**New information on
Planning applications by Cuadrilla Bowland Limited to drill at
Preston New Road (no. LCC/2014/0096)
and
Roseacre Wood (no. LCC/2014/0101)
Objection on grounds of geology and hydrogeology
by
Professor David Smythe
Emeritus Professor of Geophysics, University of Glasgow**

Summary

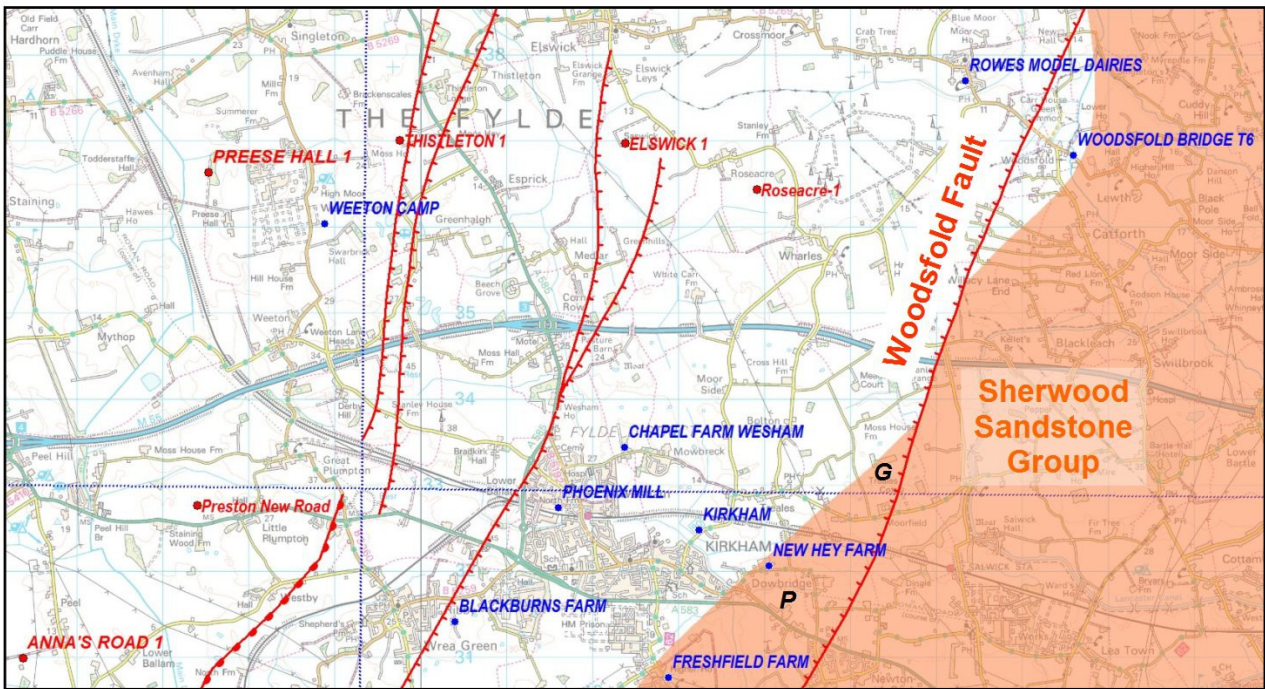
Figure 1 shows the location of some of the water wells labelled in blue, and the exploration boreholes, actual and proposed, labelled in red. The area where the MMG is at the surface (outcrop below recent glacial deposits) is uncoloured. The SSG outcrop is shown in a buff colour. Major faults as mapped by the BGS at the surface are shown in red with a comb on the downthrown side. The Principal Aquifer lies generally east of the Woodsfold Fault, and the abstraction wells here are generally drilled to 100 m or shallower depth.

The BGS solid geology maps show the Woodsfold Fault cropping out as a nearly straight line, as shown in Figure 1. But the actual location is poorly defined, because surface geological exposure is extremely limited, and the seismic information is very poor. Evidence for uncertainty includes the fact that the recent deep mapping by the BGS using seismic data conflicts to some extent with the surface maps, by up to 1 km. The interpreted sliver of MMG on the east side of the Fault, where the Woodsfold Bridge well is situated, is somewhat unsatisfactory; a better explanation of the surface geology is to place the Woodsfold Fault at outcrop just east of the water well. This solution would accord better with the recent BGS deep mapping using 2D seismic data.

Further south, the outcrop of SSG west of the Woodsfold Fault is unsatisfactory. It straddles two geology sheets; a small triangular area on the Garstang sheet, marked with a G on Figure 1, and the larger area P to the south. The Garstang sheet dates from 1990. The sliver of SSG in the Preston sheet may have been added as a new interpretation following the drilling of the Freshfield Farm well in 1988, discussed above. This interpretation is present in the BGS digital database, but has been removed from the new

edition of the Preston sheet, dated 2012. On this sheet and its accompanying cross-section running through Kirkham the SSG is at nearly 1000 m depth, and there is no outcrop of the SSG west of the Woodsfold Fault.

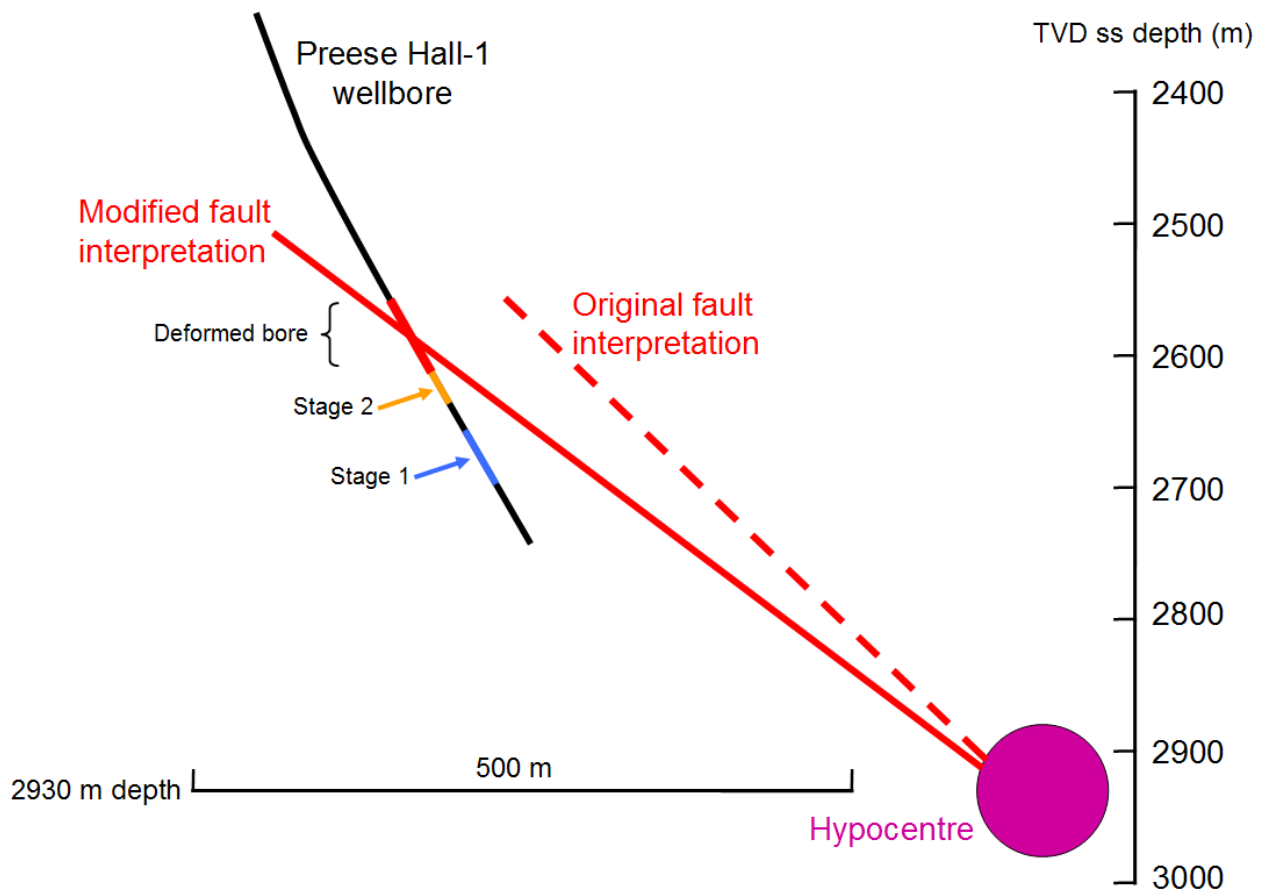
Cuadrilla has recently published a paper (Clarke *et al.* 2014) on the location of the earthquakes triggered by the drilling of Preese Hall-1 in 2011. I have no issue with the earthquake location, but the angle of the fault that slipped during the earthquakes is suspect.

The earthquake location on a fault plane, the hypocentre, is shown by the lilac ball (Fig. 2). The extrapolation upwards of the fault plane misses the wellbore, according to the original interpretation of Clarke *et al.* According to them the fault is shown on the 3D seismic data volume running upwards to the west from the hypocentre, but dying out about 100 m east of the wellbore (the dashed red line in Fig. 2). Such an interpretation mismatches the seismic data, because the dashed line representing the fault in Figure 2 cuts across the westerly-dipping seismic layering. I have re-interpreted the fault position (Smythe, for submission) to honour the seismic data, as shown by the solid red line in Figure 2. This version is consistent with the earthquake focal plane solution, and intersects the wellbore. It also shows that the fault runs through the well in the zone where the well casing was deformed. The earthquakes and the deformation happened shortly after frack stage 2, shown in yellow on the wellbore (Fig. 2).
